# **SENSITIVE RECEPTOR AND PREFERENTIAL PATHWAY SURVEY, RESPONSE TO REGULATORY COMMENTS, AND WORK PLAN FOR ADDITIONAL ASSESSMENT**

**Former Chevron Service Station 9-0121  
3026 Lakeshore Avenue  
Oakland, California**

In its January 28, 2011 letter, ACEH requested clarification and additional information on this case. In correspondence dated March 10, 2011 to ACEH, CRA provided information for technical comments 1, 3, 4, 5, and 6. Below are the comments from ACEH's letter (italicized) and CRA's additional responses.

Subject: Request for Work Plan; Fuel Leak Case No. RO0000284 and Geotracker Global ID T0600100328, Chevron #9-0121; 3026 Lakeshore Avenue, Oakland, CA 94610

**Figure 2**  
**SITE PLAN WITH PROPOSED SOIL BORING LOCATIONS**  
**FORMER CHEVRON SERVICE STATION 9-0121**  
**3026 LAKESHORE AVENUE**  
*Oakland, California*

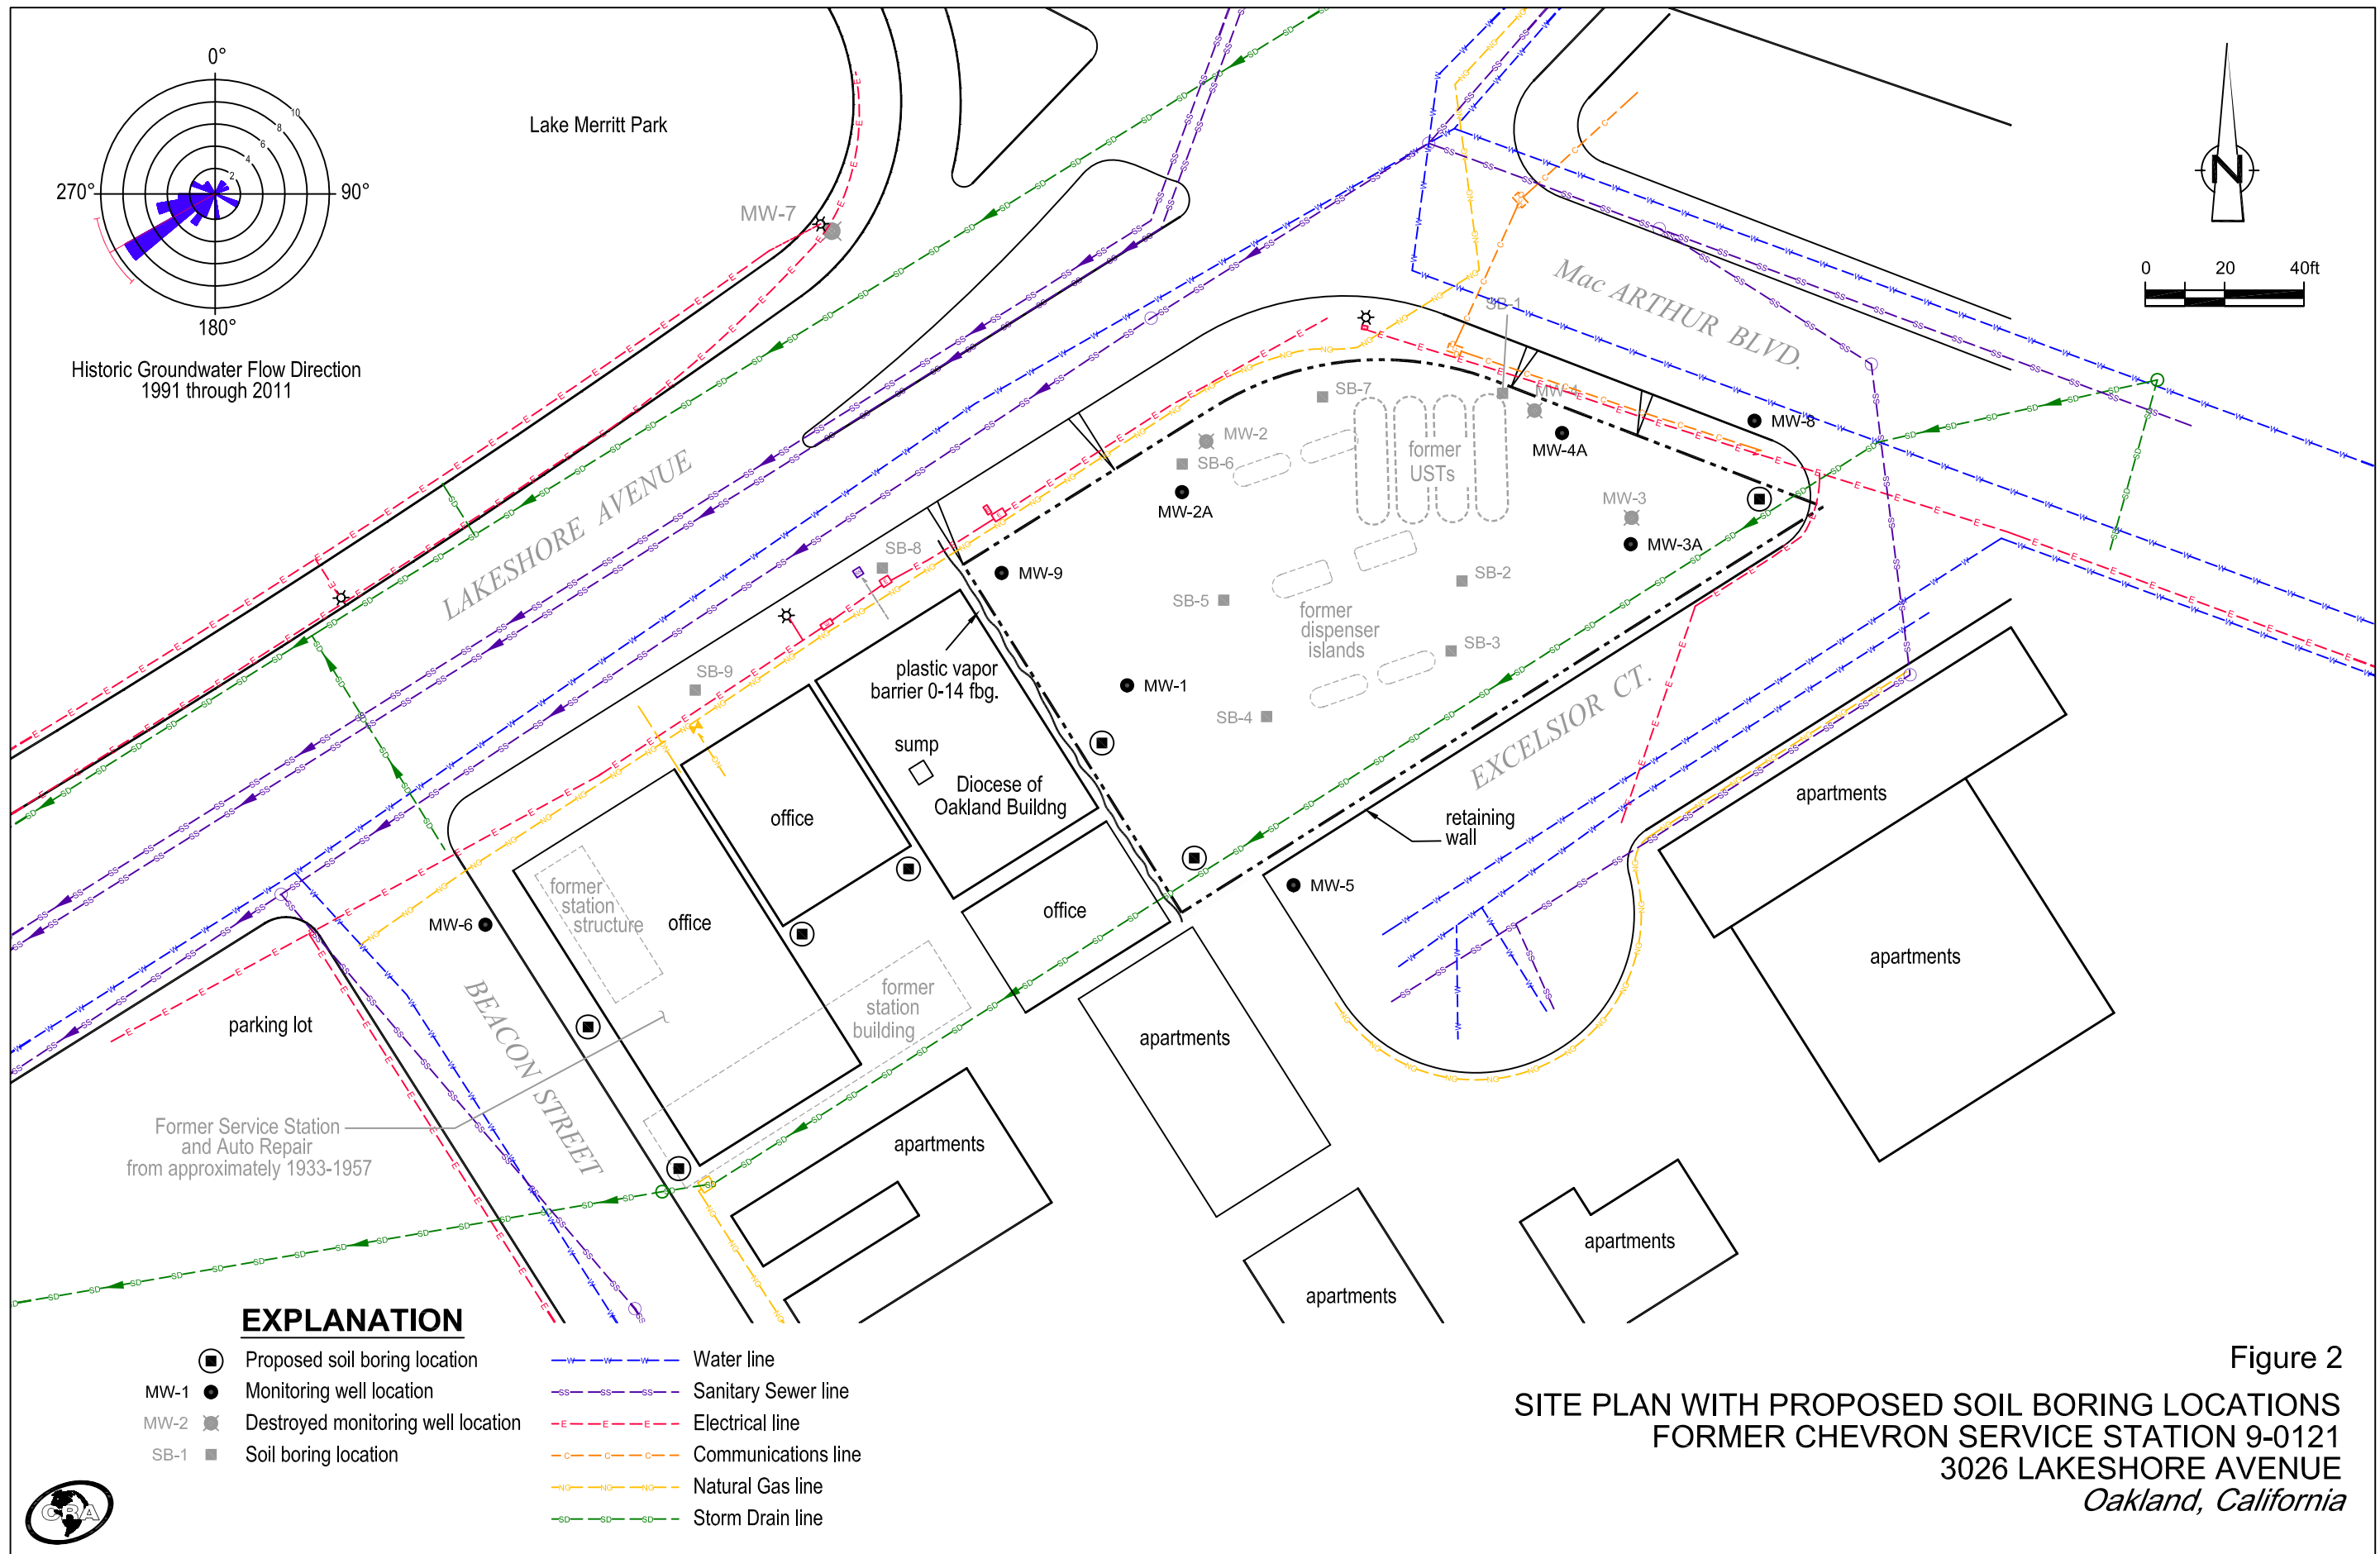
- 2.a *Similarly the additional storm drain under Lakeshore Avenue appears to be a conduit for impacted groundwater moving offsite to the northwest based on depth to groundwater and depth of the utility. Older nondetectable data from well MW-7 appears to support this interpretation.*

7. *Status of Proposed Work – A December 4, 2001 work plan proposed, and a December 6, 2001 ACEH directive letter approved, the installation of two wells and a series of soil bores along the southeastern boundary storm drain. The work was proposed to evaluate the extent of the plume towards the southeast across the storm drain line, to determine if the storm drain was acting as a preferential pathway, and to determine the effectiveness of the plastic barrier between the two sites. ACEH has not found either a report or an explanation as to why this investigation may not be necessary; please clarify the status of this investigation.*

As shown on the groundwater flow direction rose diagram presented on Figure 2, the predominant groundwater flow direction is toward the southwest. Less than nine groundwater monitoring events have shown a groundwater flow direction other than toward the south, southwest, and west. Well MW-7 is located approximately 100 feet crossgradient of the site on the northwest side of Lakeshore Avenue. Also considering the historical distribution of dissolved hydrocarbon in all the monitoring wells, we disagree that MW-7 demonstrates utilities beneath Lakeshore Avenue are acting as preferential pathways.

CRA agrees an assessment of the storm drain sewers is needed to determine if hydrocarbon migration is occurring along them. CRA proposes advancing two soil borings along the 7 foot diameter storm sewer at the site's southern edge and two soil borings in the sidewalk of Beacon Street to the southwest. These locations are similar to the locations proposed in the 2001 work plan. Well MW-5 is located on the opposite side of this utility in Excelsior Court and occasionally contains low dissolved hydrocarbon concentrations. There is no correlation between depth to groundwater and when hydrocarbons are and not detected in well MW-5. This data suggests that this storm sewer is not significantly affecting the flow of groundwater. Therefore, CRA does not propose additional wells along Excelsior Court. The additional assessment details are proposed below.

CRA proposes advancing seven soil borings. Proposed locations are shown on Figure 2 and details are presented below.
